**LEGAL ADVERTISEMENT
HISTORIC PRESERVATION BOARD
CITY OF PORTLAND
Public comments are taken at all meetings.**

**PUBLIC HEARING
1375 WESTBROOK STREET**

**WORKSHOP (3rd)
17 CARLETON STREET**

RE: August 5, 2015 Workshop to Consider Revised for India Street Historic District,
Relationship of Historic District Designation to Proposed Form-
Based Code

12' x 24' Addition
Scale: 1/4" = 1'

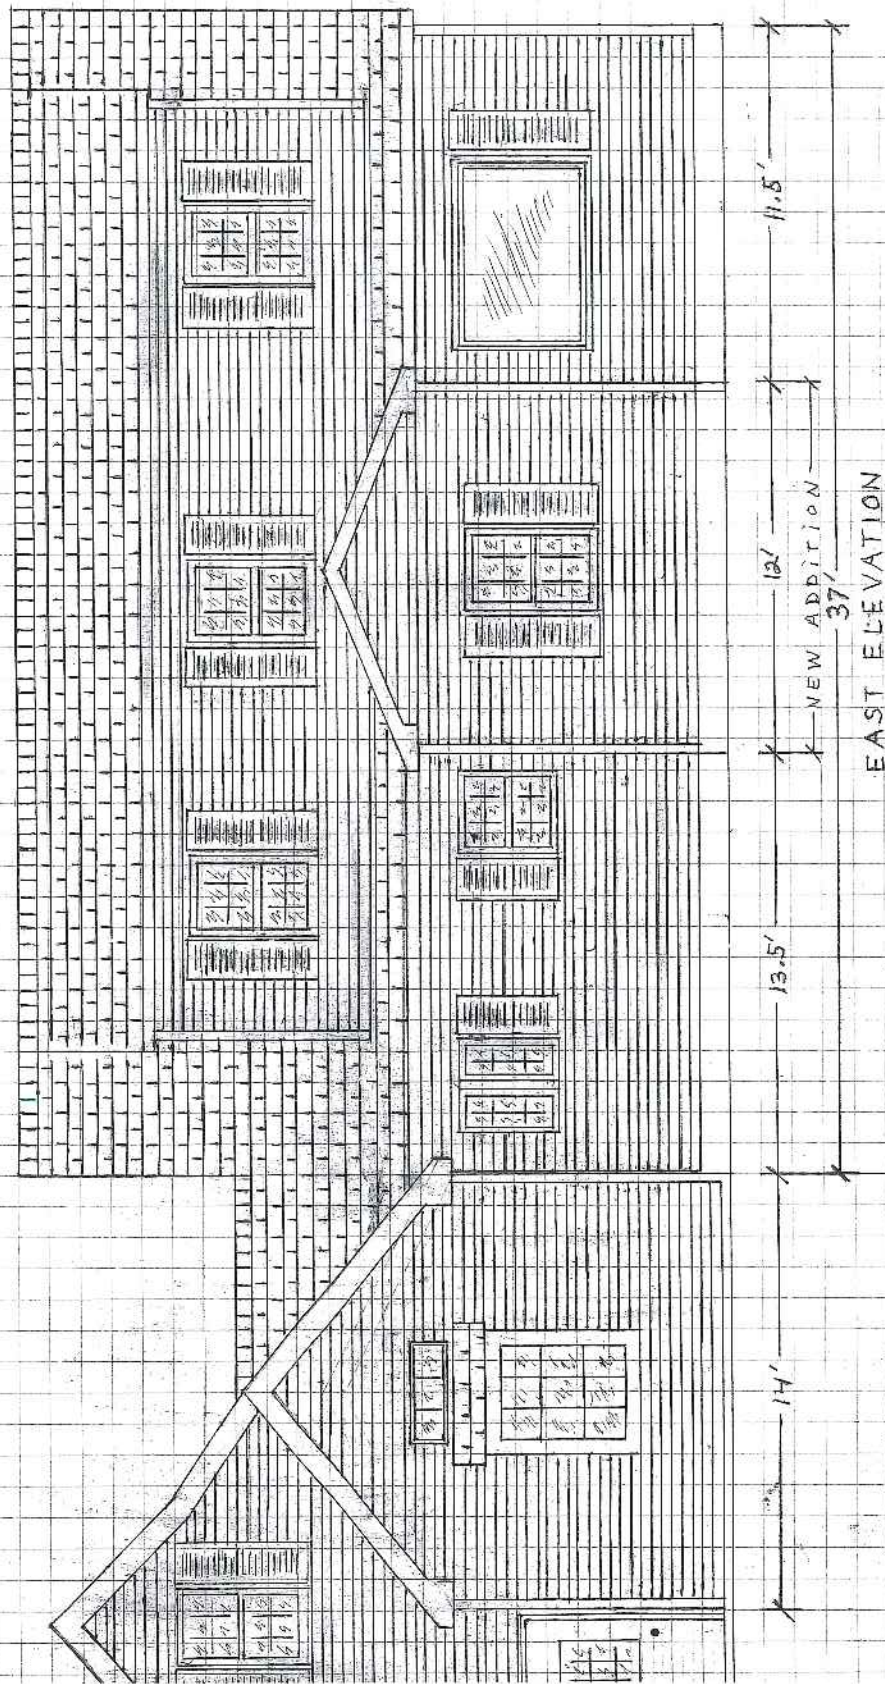
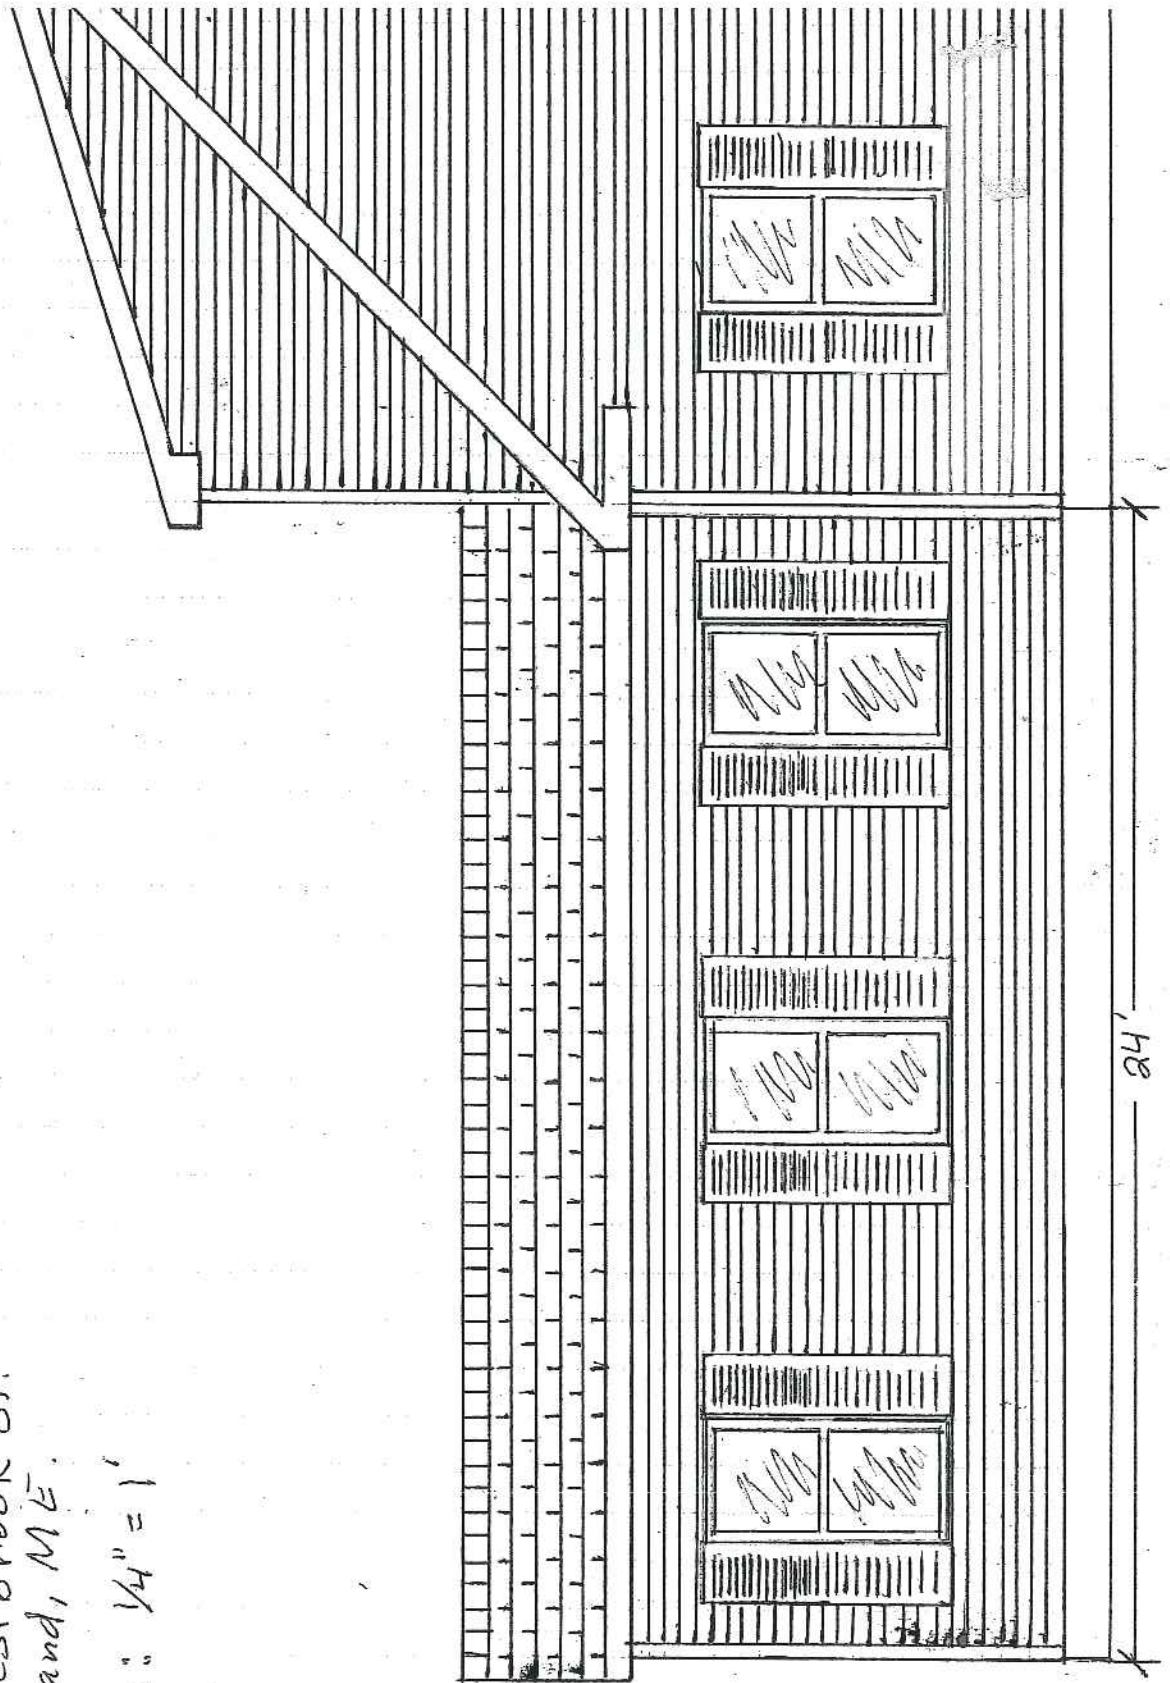
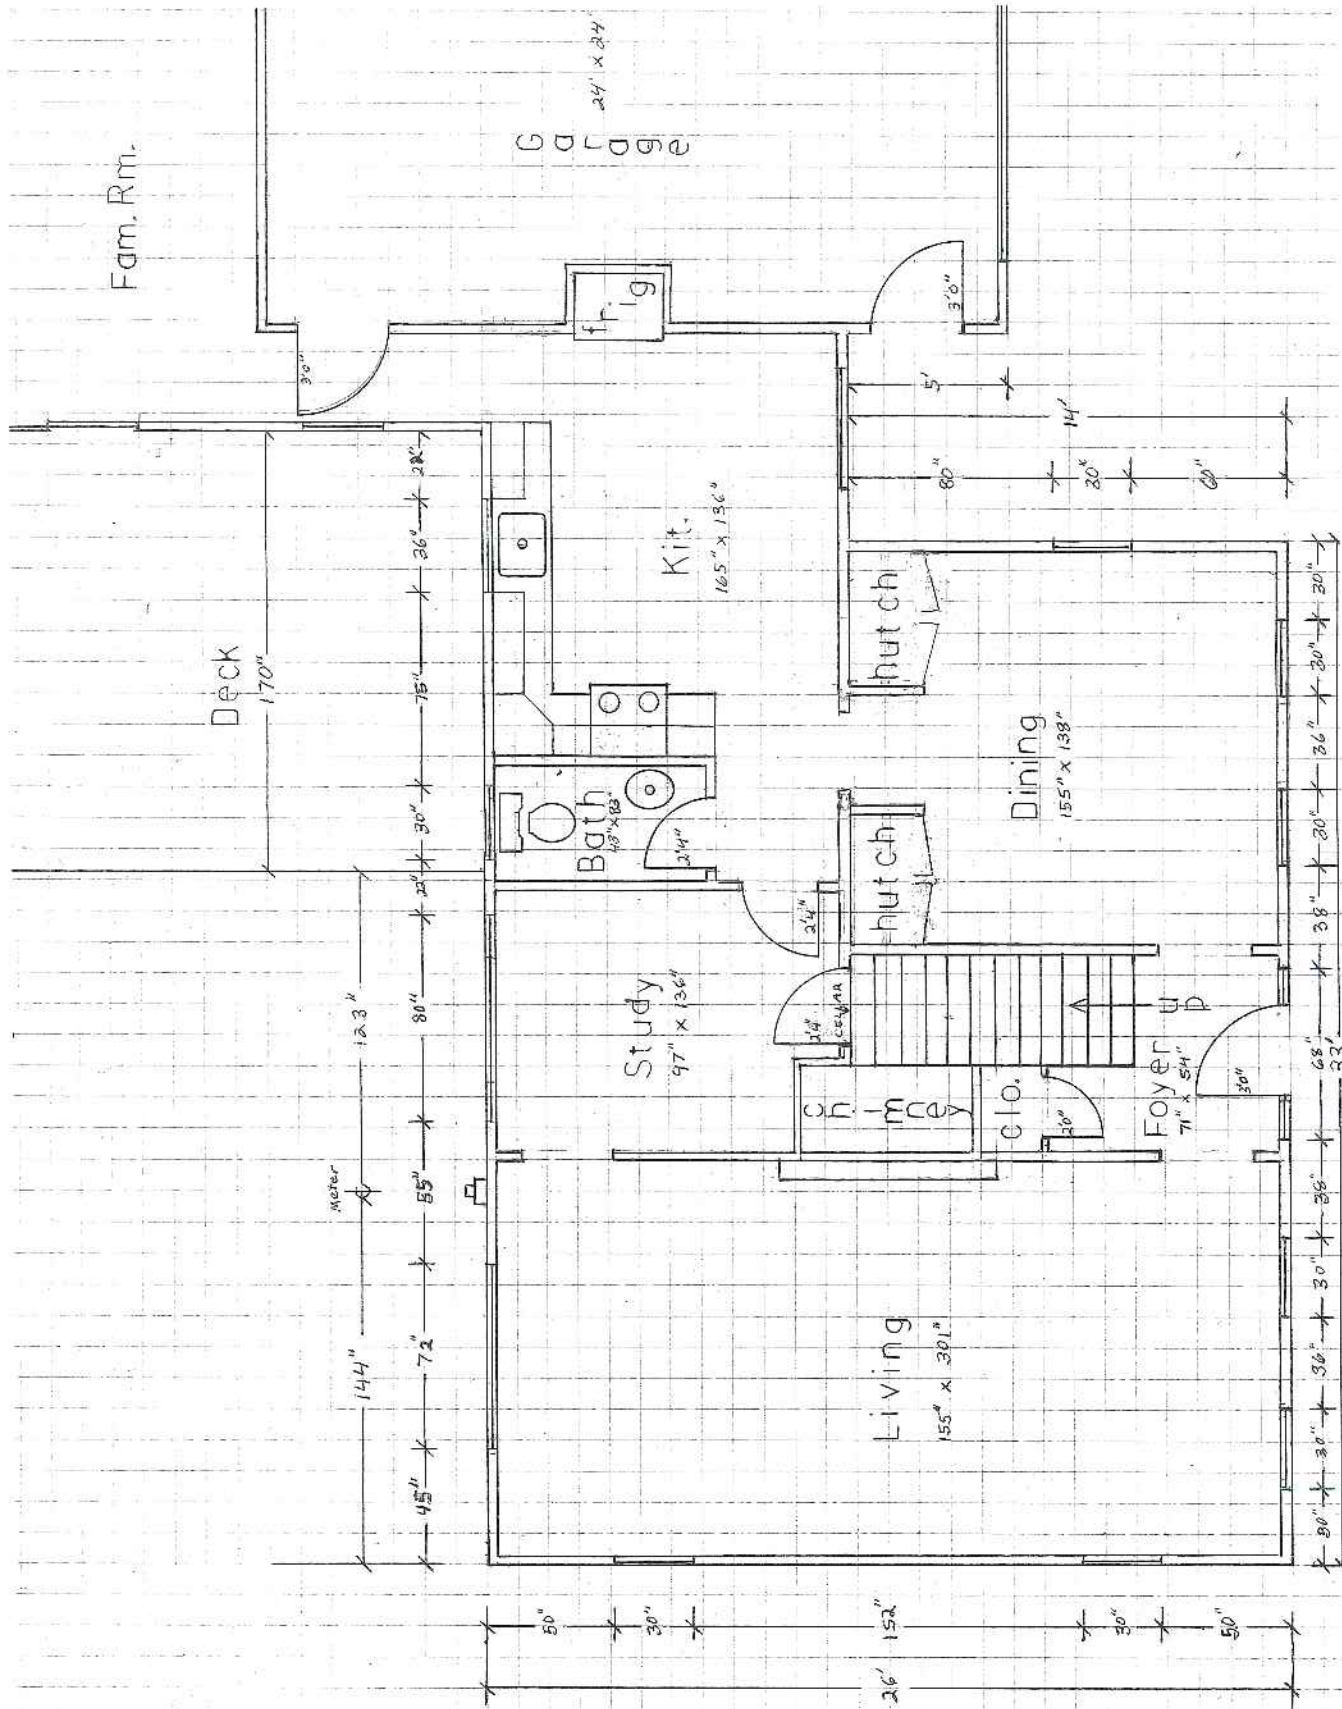
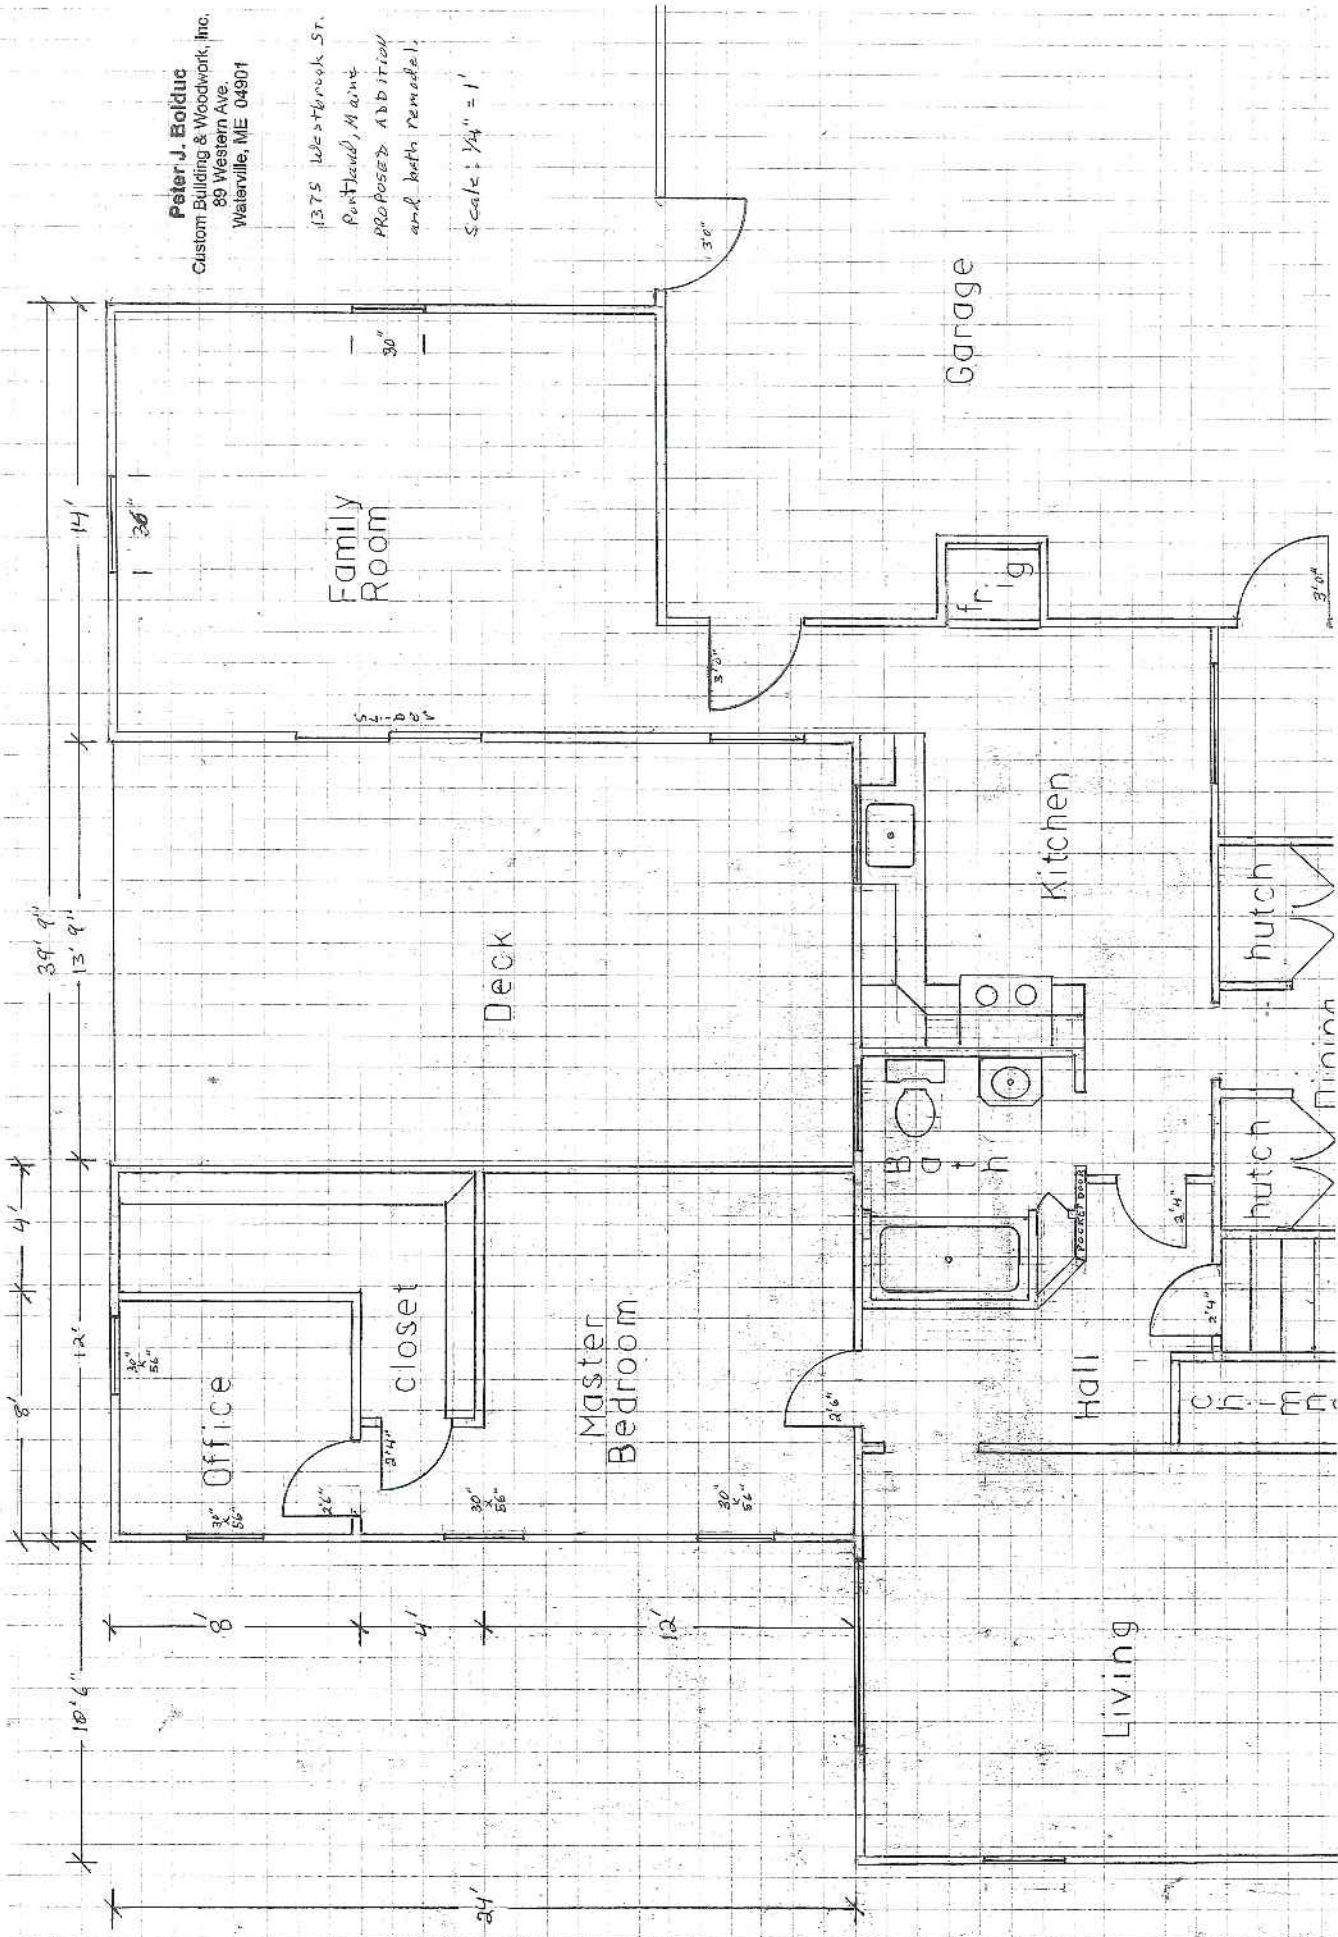
The limited visibility of the proposed addition, the non-contributing status of the property, and the location of the house at the periphery of the historic district make this project review relatively minor compared to some of the additions reviewed by the Board. Nonetheless, the review process is an opportunity to ensure that the proposed work will be compatible with the character and appearance of the original building, and not inappropriate for the Stroudwater District.
